Access Compliance Report

Public Rights-of-Way

Intersection ID: 21378	Main Street: CAMBRIDGE BELTWAY DR	Cross Street: LENOX POINTE DR	Location: W
ADA ID: A85CC9D7AC51	Ramp Type: PerpDiag	Initial Pass/Fail: Fail	Overall Compliance: No
		Severity Score: 8.75

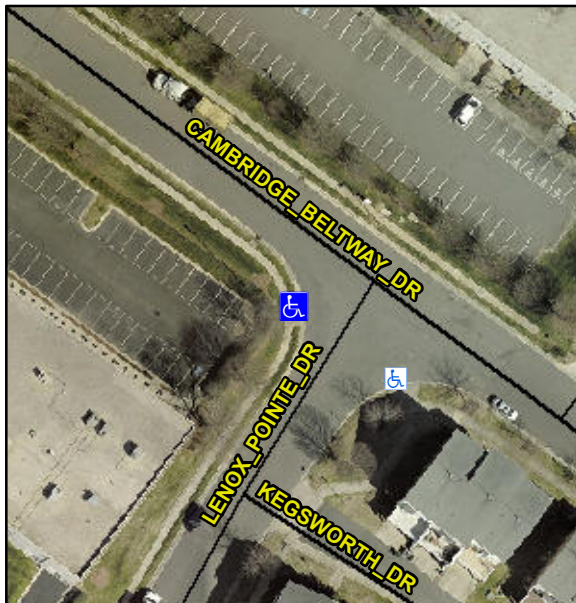
R304.5.1

Compliance	Description	Data	Compliance	Description	Data
N/A	Ramp Length (in)	97.0	Yes	Ramp Slope (%)	7.9
No	Ramp Width (in)	44.5	Yes	Ramp XSlope (%)	0.8
N/A	Flare Type LT	N/A	N/A	Flare Type RT	N/A
N/A	Flare Slope LT (%)	N/A	N/A	Flare Slope RT (%)	N/A
N/A	Flare Traversable LT?	N/A	N/A	Flare Traversable RT?	N/A
N/A	Landing Length (in)	N/A	N/A	DWS Provided?	N/A
N/A	Landing Width (in)	N/A	N/A	DWS Contrast?	N/A
N/A	Landing Slope (%)	N/A	N/A	DWS Length (in)	N/A
N/A	Landing X Slope (%)	N/A	N/A	DWS Full Width?	N/A
N/A	Landing Curb? (Y/N)	N/A	N/A	DWS Offset (in)	N/A
N/A	Shared Landing?	N/A			
N/A	Gutter Ponding?	N/A	N/A	Gutter Slope (%)	N/A
N/A	Gutter Lip Ht (in)	N/A	N/A	Gutter X Slope (%)	N/A
N/A	Painted X Walk1?	No	N/A	Painted X Walk2?	No
	X Walk 1 Direction	To SE		X Walk 2 Direction	To NE
N/A	X Walk 1 Width (in)	N/A	N/A	X Walk 2 Width (in)	N/A
	X Walk 1 Slope (%)	0.3		X Walk 2 Slope (%)	1.2
	X Walk 1 X Slope (%)	0.4		X Walk 2 X Slope (%)	1.3

Remove & Replace Curb Ramp With Two New Directional Ramps or Equivalent.
